# Access Compliance Report

## Public Rights-of-Way

### (Curb Ramps)

Intersection ID: 13647	Main Street: CLAYMONT_DR	Cross Street: SCHUBERT_PL	Location: SE
ADA ID: B587027A16F3	Ramp Type: BlendTrans1	Initial Pass/Fail: Fail	Overall Compliance: No
Severity Score: 8.75			
Codes/Mitigation Info/Possible Solution		Field Measurements/Component Compliance

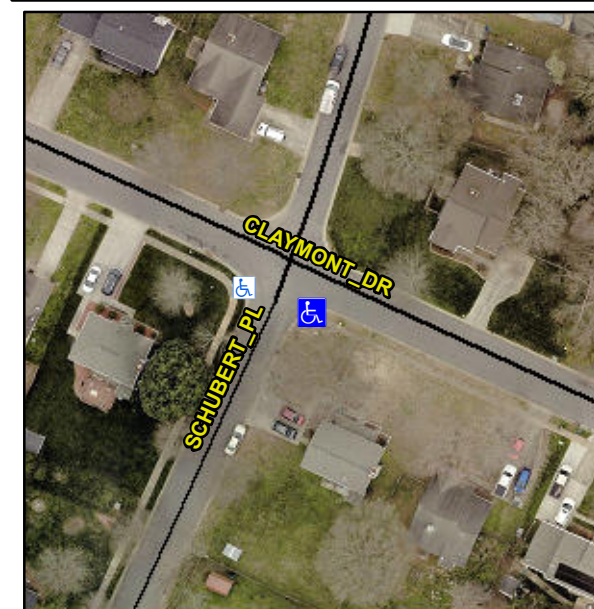
**Not Found, R304.5.1**

Compliance	Description	Data	Compliance	Description	Data
N/A	Ramp Length (in)	46.0	Yes	BlendTrans Slope (%)	3.5
No	Ramp Width (in)	47.5	Yes	BlendTrans XSlope (%)	1.8
N/A	Flare Type LT	N/A	N/A	Flare Type RT	N/A
N/A	Flare Slope LT (%)	N/A	N/A	Flare Slope RT (%)	N/A
N/A	Flare Traversable LT?	N/A	N/A	Flare Traversable RT?	N/A
N/A	Landing Length (in)	N/A	N/A	DWS Provided?	N/A
N/A	Landing Width (in)	N/A	N/A	DWS Contrast?	N/A
N/A	Landing Slope (%)	N/A	N/A	DWS Length (in)	N/A
N/A	Landing X Slope (%)	N/A	N/A	DWS Full Width?	N/A
N/A	Landing Curb? (Y/N)	N/A	N/A	DWS Offset (in)	N/A
N/A	Shared Landing?	N/A			
N/A	Gutter Ponding?	N/A	N/A	Gutter Slope (%)	N/A
N/A	Gutter Lip Ht (in)	N/A	N/A	Gutter X Slope (%)	N/A
N/A	Painted X Walk1?	No	N/A	Painted X Walk2?	N/A
	X Walk 1 Direction	To NW		X Walk 2 Direction	N/A
	X Walk 1 Width (in)	N/A		X Walk 2 Width (in)	N/A
	X Walk 1 Slope (%)	3.4		X Walk 2 Slope (%)	N/A
	X Walk 1 X Slope (%)	1.5		X Walk 2 X Slope (%)	N/A

N/A	Ramp inside XWalk1?	N/A	N/A	Ramp inside XWalk2?	N/A
	Road Slope (%)	1.5		Clear Space?	N/A
	Road X Slope (%)	3.4	N/A	Clear Space to XWalk (in)	N/A
N/A	Any Obstructions?	N/A	N/A	Storm Grate/Utility Hazard?	N/A
	Obstruction Type			Storm Grate/Utility Type	
		N/A			N/A
			Yes	Surface Condition? (G/P)	Good
			No	Curb Slope (%)	8.1

**Remove & Replace Curb Ramp With Two New Directional Ramps or Equivalent.**
